North Little Rock Planning Commission
July 14, 2026 - Agenda / Public Hearing 4:00 PM
City Council Chambers – 300 Main Street, NLR, AR 72114

1. RZ2026-10 Faulkner Crossing Phase 12 – 14 Rezoning from R2 to R3 and RU to allow development of a residential subdivision @ the East end of Amaranth Dr

2. SD2026-37 Faulkner Crossing Phase 12 – 14 Preliminary Plat for 84 acres 429 lots constructed in 3 phases @ the East end of Amaranth Dr
3. SD2026-38 Lakewood Addition Lot 4B, Blk 67, SPR for Goodwill Donation Drop-off @ 4583 Fairway Ave

SITE PLAN REVIEW

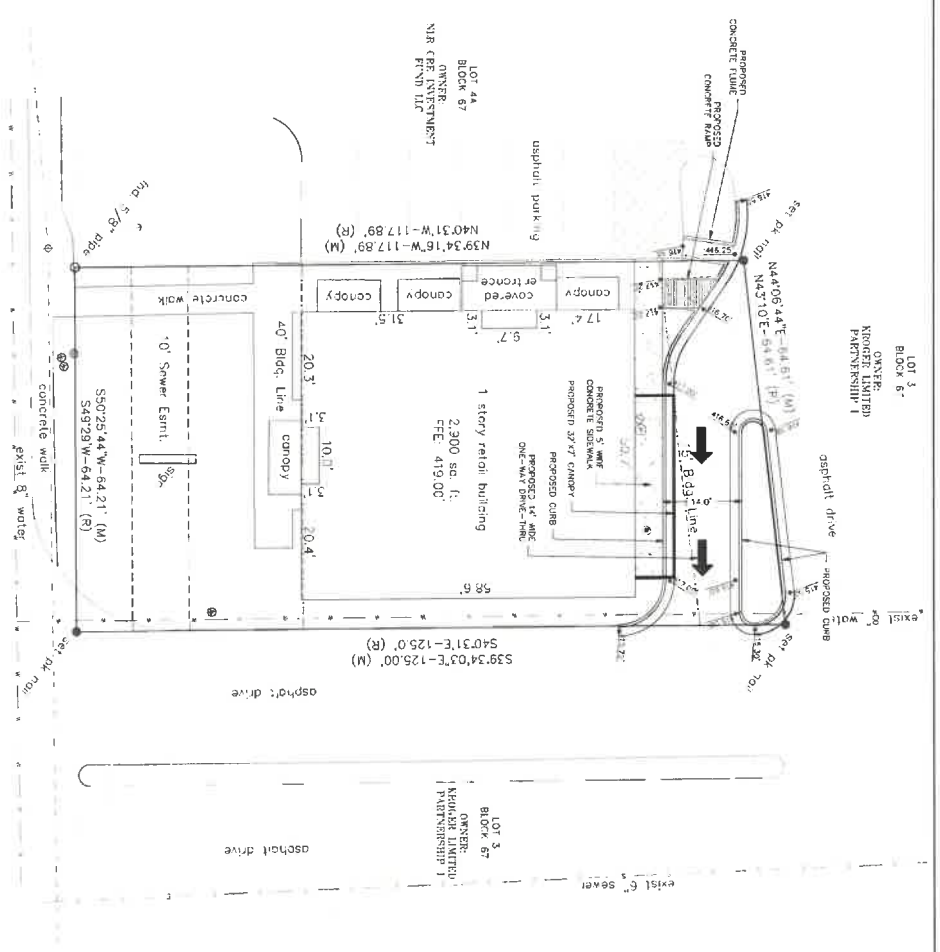
1. The typical rear yard setback for C3 zoned property is 20-feet. The plan indicates the placement of a 15-foot rear yard setback. Provide approval from Board of Zoning Adjustment for the rear yard setback variance prior to requesting a building permit for the canopy construction.

① SITE PLAN W/ SURVEY OVERLAY
1" = 60'-0"

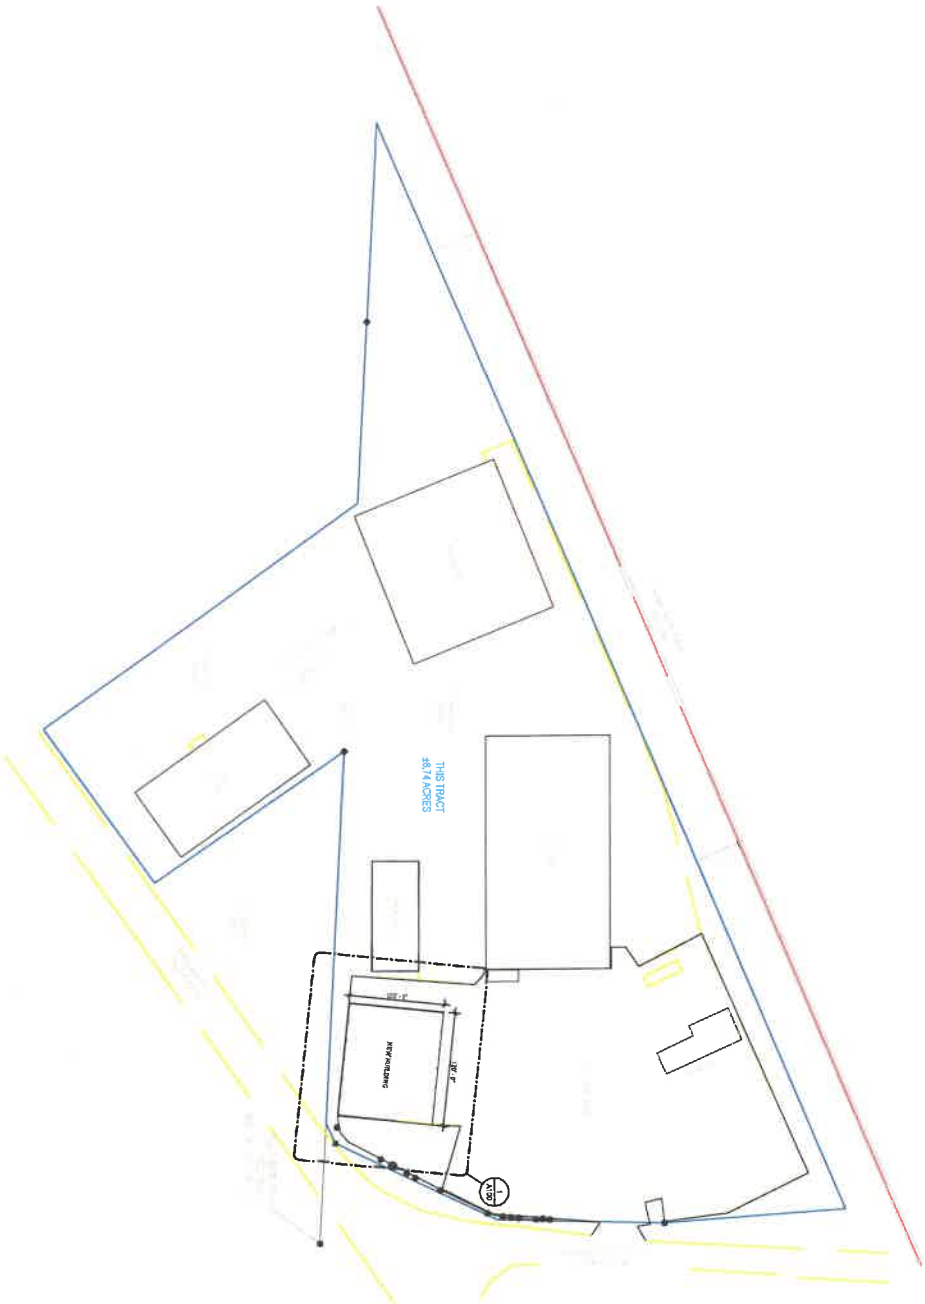
1. Parking for Multi-family with 0 to 250 units requires the placement of 1.8 spaces per dwelling unit. The general notes indicate the requirement as 1.5 spaces per dwelling unit. Please correct the general note. (The number of parking spaces indicated is more than adequate to meet the typical minimum requirement of 130 parking spaces.)

2. Engineering requirements on detention:
 - a. Provide on-site storm water detention as well as clear calculations showing that detention volume is sufficient or demonstrate to City Engineer that on-site detention is not required (based on proposed development) by providing detention calculations showing pre and post site runoff comparisons.

- k. Provide half of the required 80 foot right-of-way.
- l. Street improvements must be approved by City Engineer and accepted by City Council.
- m. Show and label boundary of detention area as a drainage easement.

7. Meet the requirements of the Master Street Plan, including:
 - a. Provide 100-foot right of way dedication along with the required 60-foot of pavement width, curb, gutter and sidewalk and a dedicated bike lane or provide a waiver of the requirements from City Council.
